MEMORANDUM

To: Luke Schwartz, Transportation Manager, City of San Luis Obispo

From: Joe Fernandez and Michelle Matson, CCTC

Subject: 600 Tank Farm Road – Access Evaluation

Preferred Alternative and Recommendations

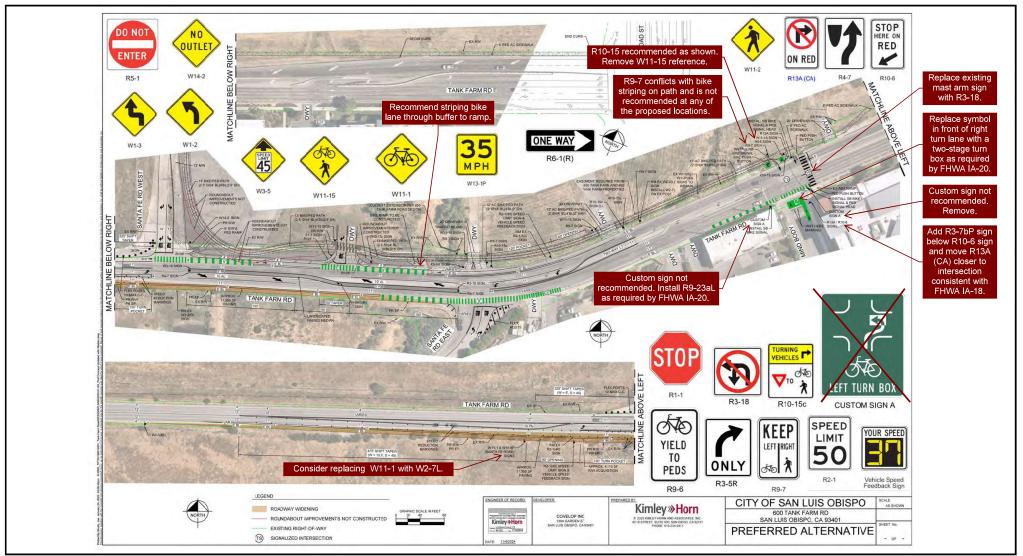
The proposed interim side-street-stop control at Tank Farm Road/Santa Fe Road West (#3) would provide acceptable automobile operations under Existing, Near Term, and Cumulative conditions with the addition of project traffic. Side-street-stop control does not support pedestrian and cyclist crossings of Tank Farm Road at this location and is inconsistent with the prior recommendations to construct a roundabout. However, there are no destinations immediately across Tank Farm Road from the project, the roundabout is not needed to accommodate vehicular volumes without the Prado Road extension, and interim access is proposed which provides acceptable vehicular operations and pedestrian and cyclist connectivity to the east.

The proposed intersection control and CCTC's recommendations are shown in **Attachment A**. The roundabout is recommended as a future improvement and will be necessary to accommodate traffic levels when

Santa Fe Road is extended to Prado Road. We recommend that the project be conditioned to make fair share contributions towards the roundabout and that frontage designs accommodate the facilities planned in the Active Transportation Plan and Circulation Element.

The preferred alternative for intersection control and recommendations are shown in Attachment A.
